**BAKERSFIELD CITY SCHOOL DISTRICT
RELOCATION OF (9) MODULAR CLASSROOMS AND
(1) MODULAR RESTROOM AT FRANKLIN ELEMENTARY SCHOOL
BAKERSFIELD, KERN COUNTY, CALIFORNIA**

Job No. 1348
Appl. No. 15-6
File No. 03-123703

ADDENDUM NO. #03

ITEM • 3-5
REF. DSA APPROVED
DRAWING, SHEET AI

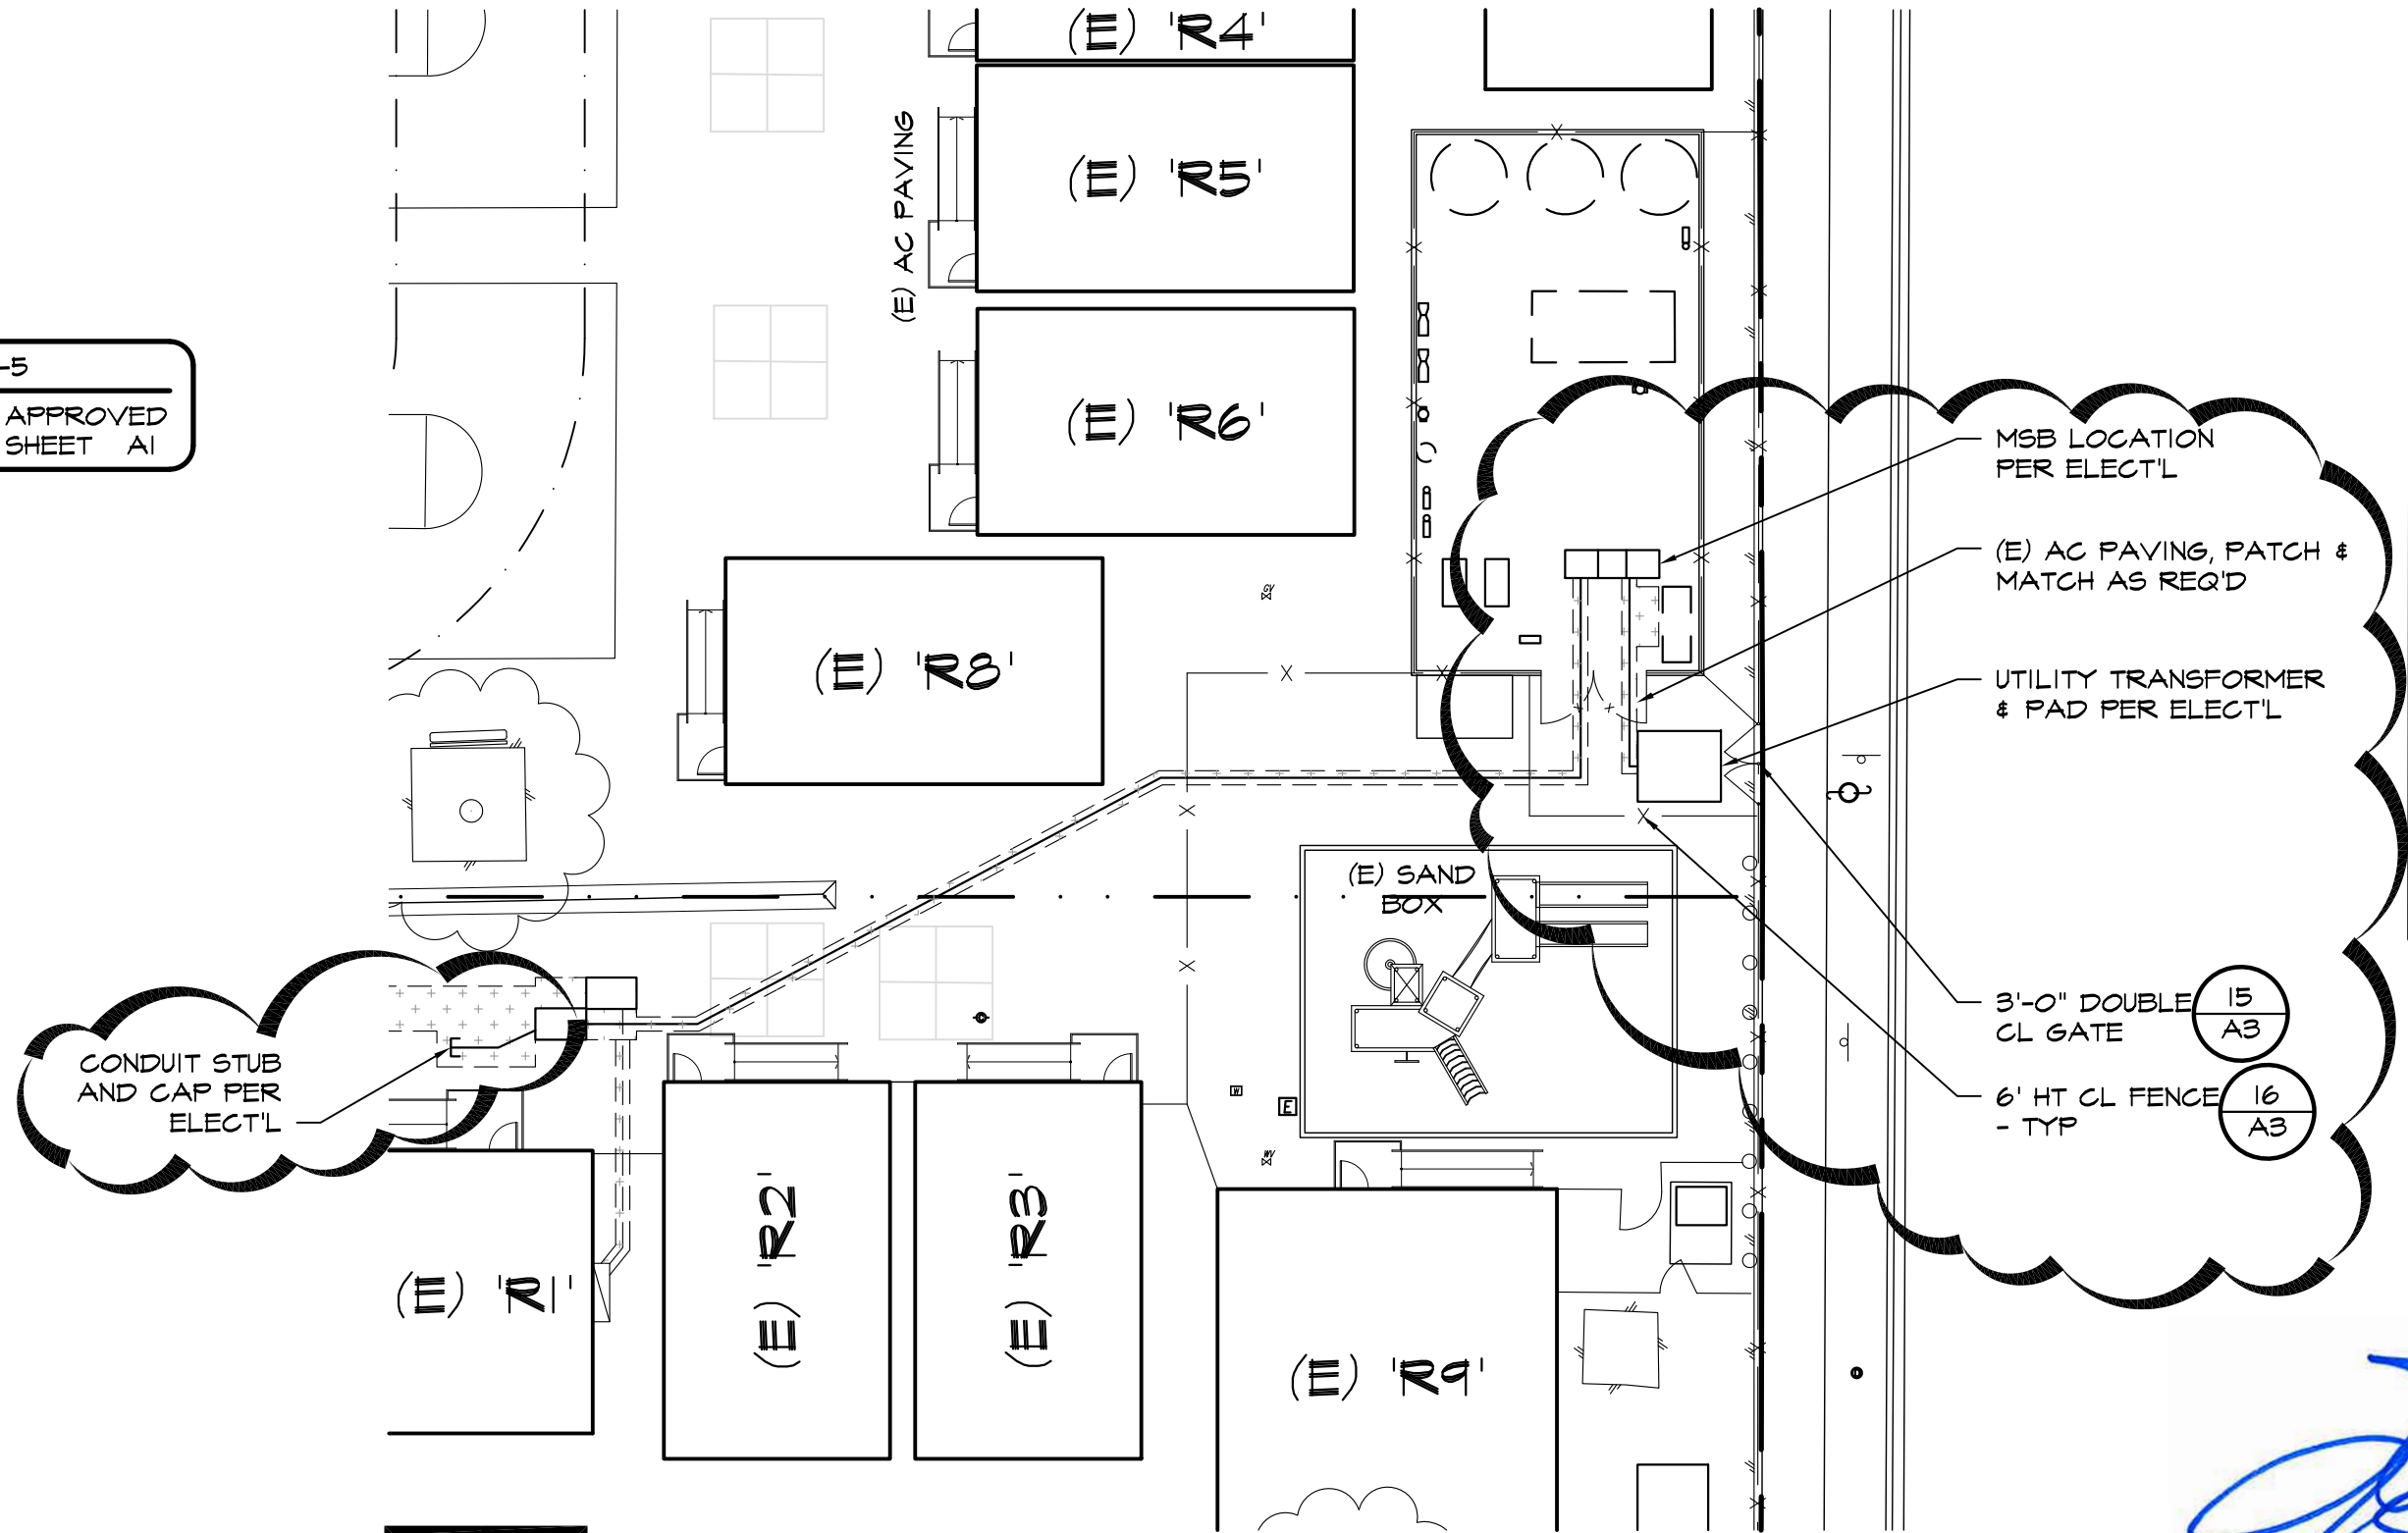
- 3-5) Refer to DSA Approved Project Drawings, Sheet No. A1 OVERALL SITE PLAN;
- a. ADD: Chain link fencing and gates for utility transformer as indicated per attached Drawing No. 5. See Also Item #1 of this Addendum.

ITEM • 3-6a

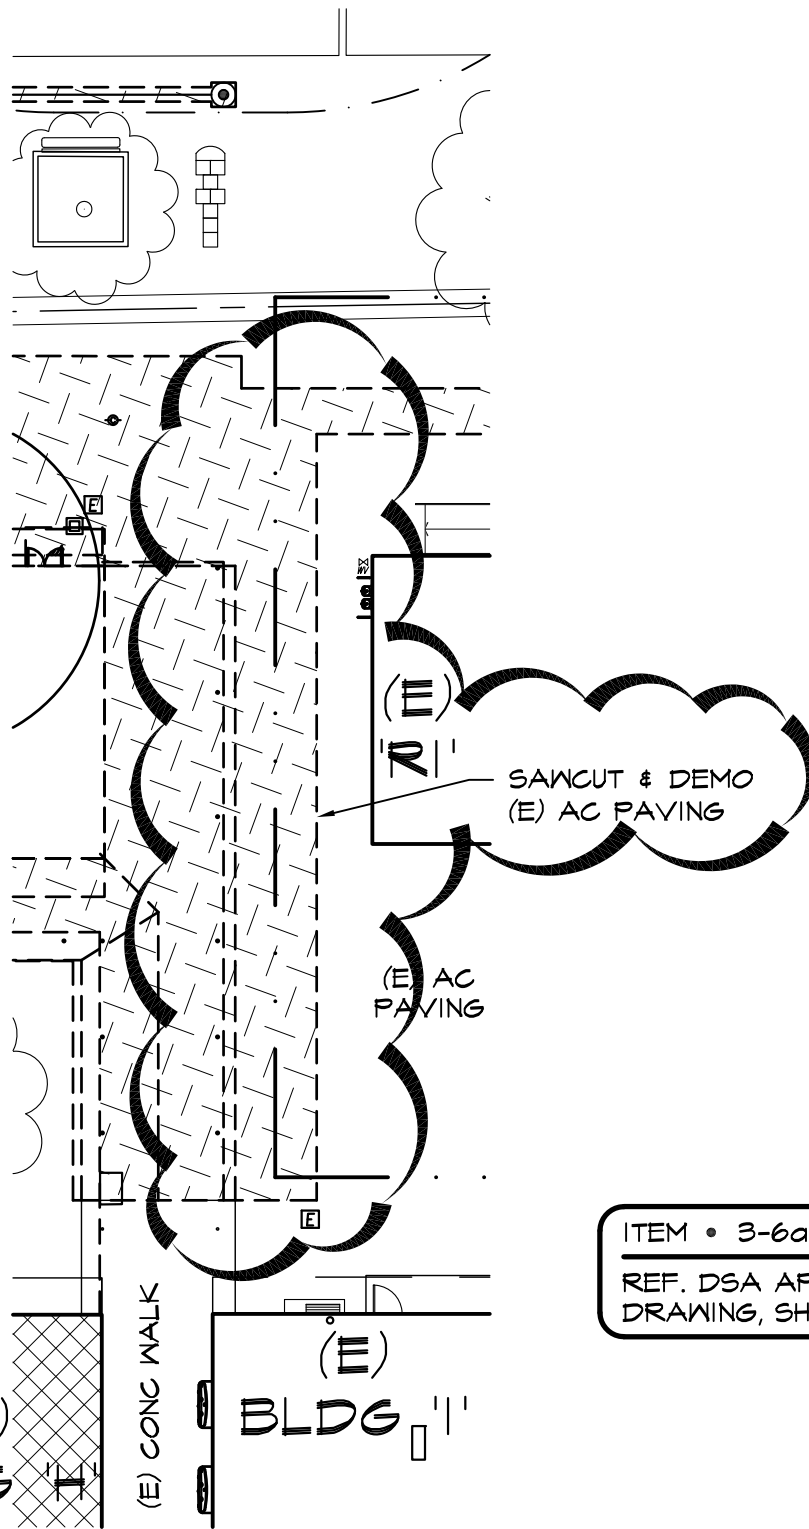
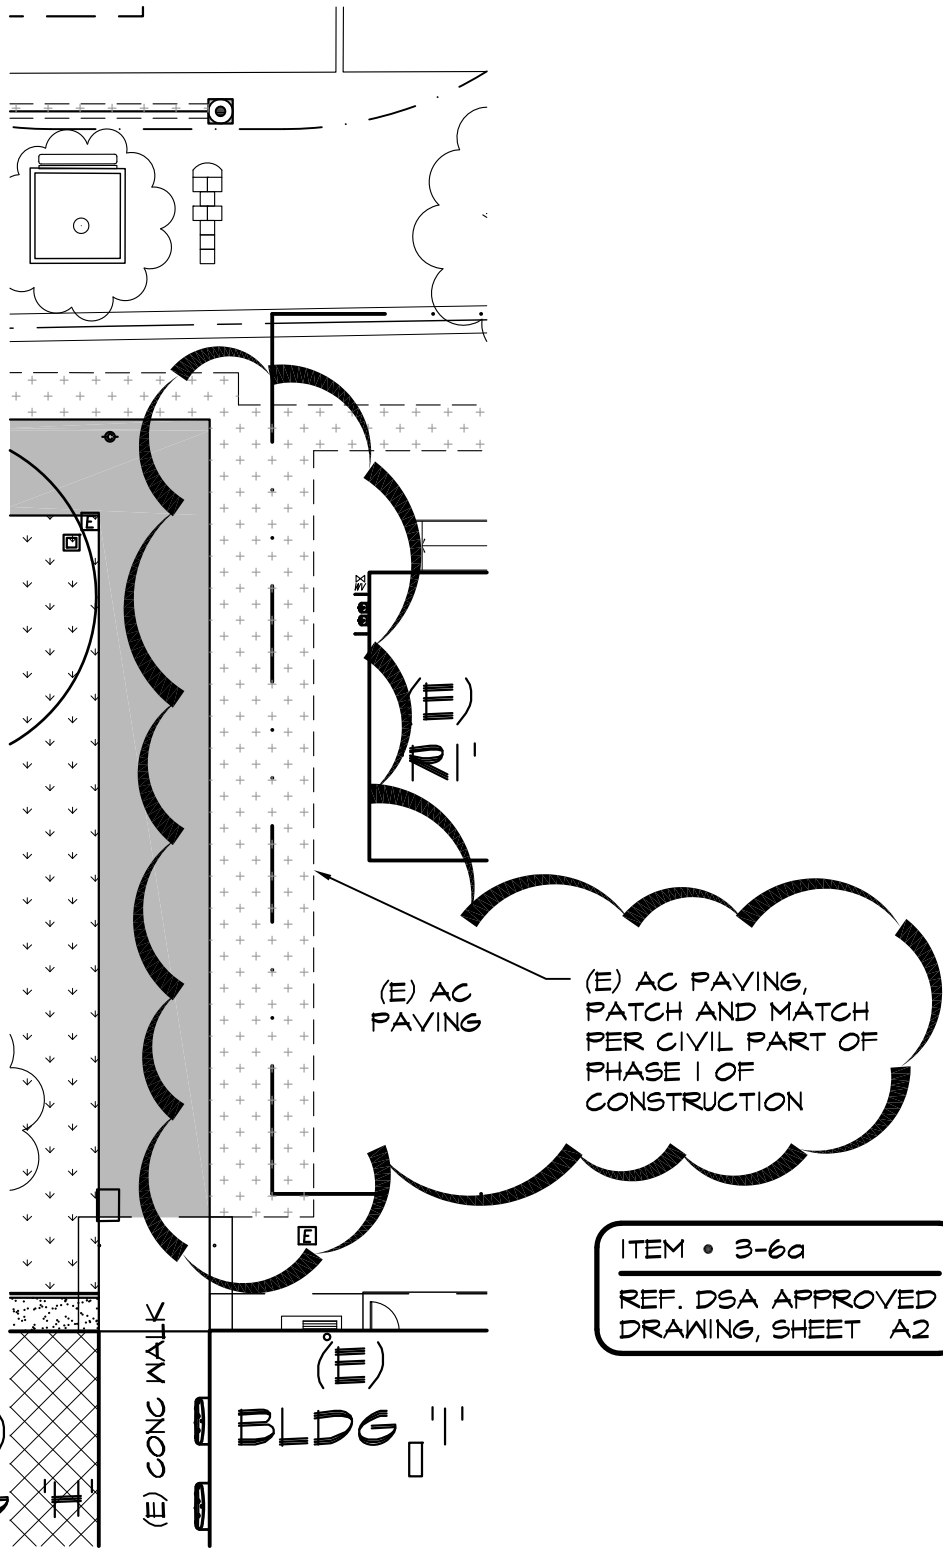
- 3-6) Refer to DSA Approved Project Drawings, Sheet No. A2 PARTIAL SITE PLAN & PARTIAL DEMO SITE PLAN;
- a. ADD: Demolition of AC paving and AC Paving for revised waterline location as indicated per attached Drawing Nos. 06 and 07. See Also item #4 of this Addendum.

08

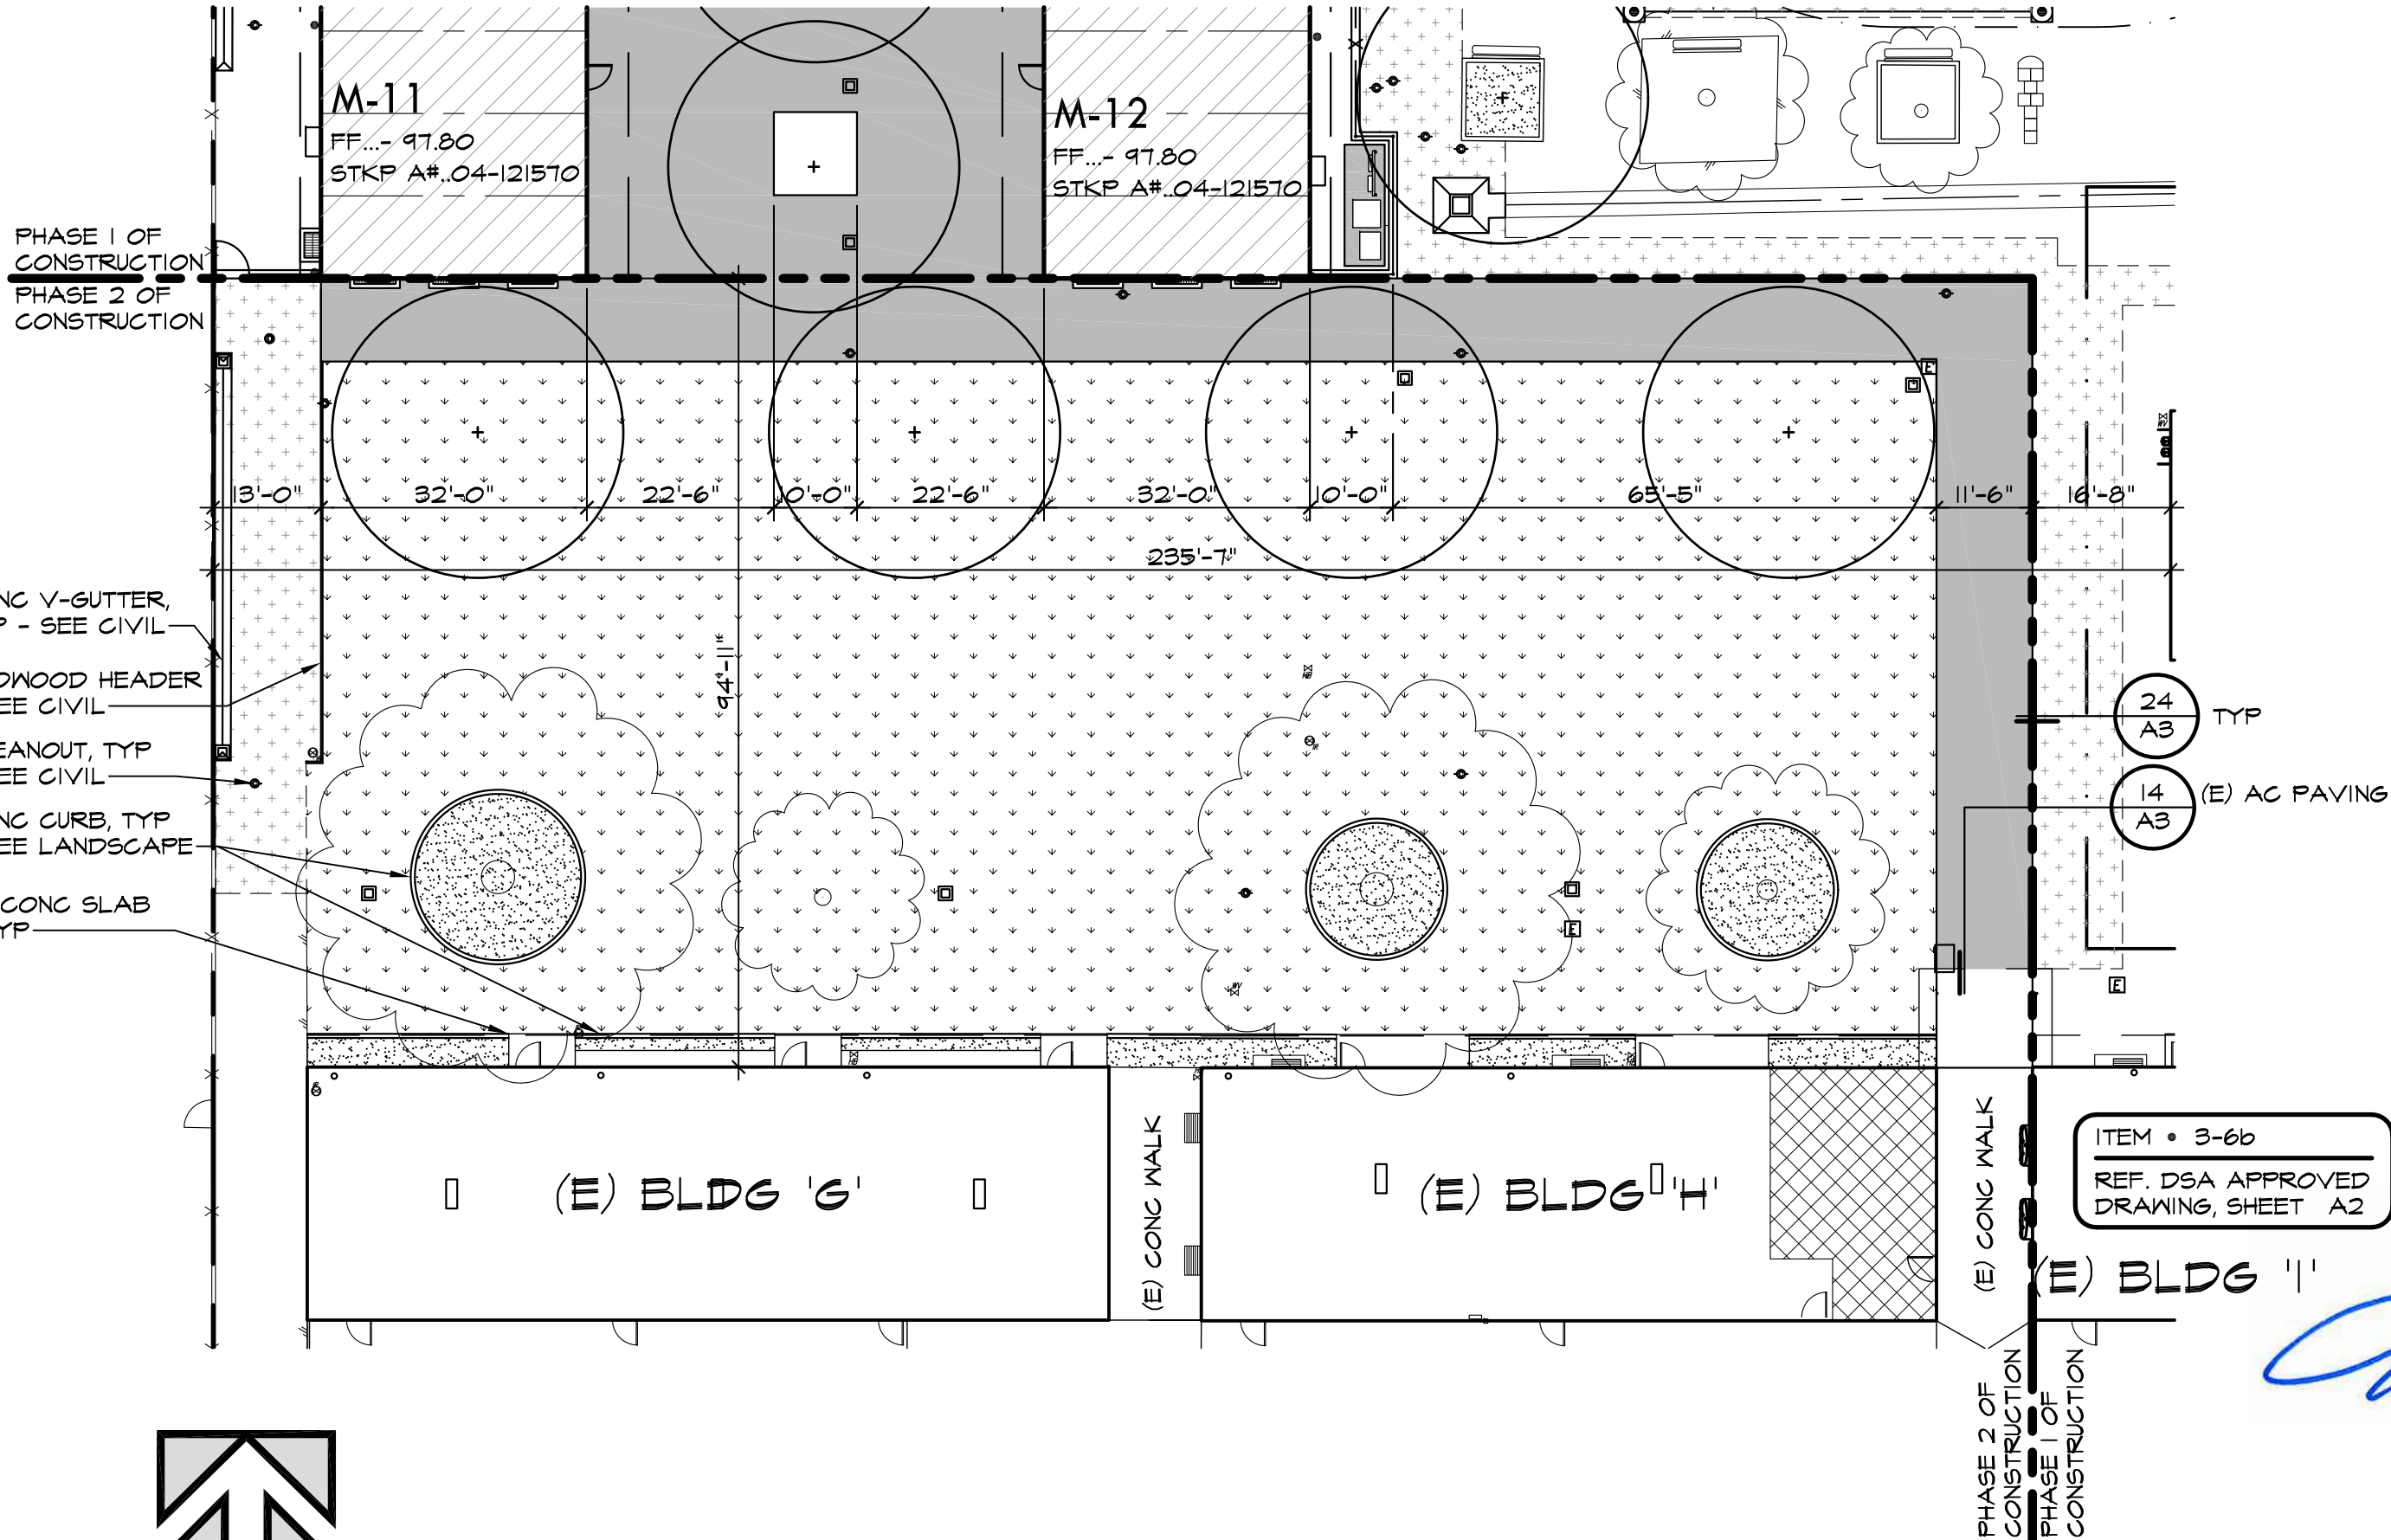
- b. ADD: Construction Phasing shall be as indicated per attached Drawing Nos. 08 and 09.
- 3-7) Refer to DSA Approved Project Manual, INDEX, DIVISION 00 PROCUREMENT & CONTRACTING REQUIREMENTS and Addendum No. 01, Item 1-1b., SECTION 00 11 16 NOTICE TO BIDDERS, ITEM #3;
